Compilation of comments received on ISO/DTS 20012	Date:2008-01-08	ISO/TC 197 N 389 Annex A
		Reference document: ISO/TC 197 N 375

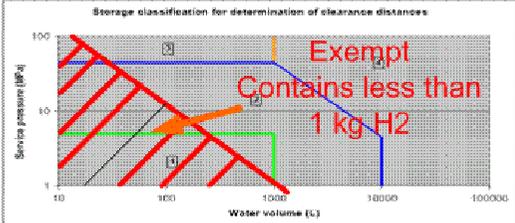
US	13.2.2.1: Safety distances from gaseous hydrogen storage systems	Figure 3:	TE	<p>Pressure and volume storage requirements need to be reviewed to ensure appropriate limits are established.</p> <p>All storage systems that can contain less than 0.98 kg at rated pressure and 15 degrees C must be exempt from consideration in this document as these are typically transportable vessels refilled off site. For example, NFPA 55 exempts (This chapter shall not apply to) individual systems using containers having a total hydrogen content of less than 11 m3 (400scf) if each system is separated by a distance not less than 1.5 m (5 ft)</p>

Hydrogen at MPa (and 15 deg C)	g/l	exempt qty (grams)	exempt volume (liters)	1	0.92	988.8	1074.2	5	4.16	988.8	237.7	Fix Figure 3.	
Hydrogen at MPa (and 15 deg C)	g/l	exempt qty (grams)	exempt volume (liters)															
1	0.92	988.8	1074.2															
5	4.16	988.8	237.7

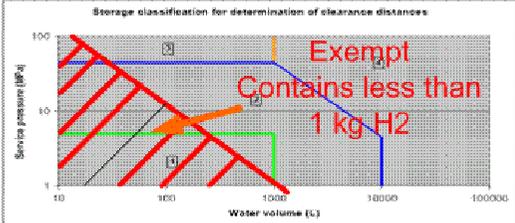
US	13.2.2.1: Safety distances from gaseous hydrogen storage systems	Figure 3:	TE	<p>Pressure and volume storage requirements need to be reviewed to ensure appropriate limits are established. All storage systems that can contain less than 0.98 kg at rated pressure and 15 degrees C must be exempt from consideration in this document as these are typically transportable vessels refilled off site. For example, NFPA 55 exempts (This chapter shall not apply to) individual systems using containers having a total hydrogen content of less than 11 m3 (400scf) if each system is separated by a distance not less than 1.5 m (5 ft)</p>

Hydrogen at MPa (and 15 deg C)	g/l	exempt qty (grams)	exempt volume (liters)	1	0.92	988.8	1074.2	5	4.16	988.8	237.7	Fix Figure 3.	
Hydrogen at MPa (and 15 deg C)	g/l	exempt qty (grams)	exempt volume (liters)															
1	0.92	988.8	1074.2															
5	4.16	988.8	237.7
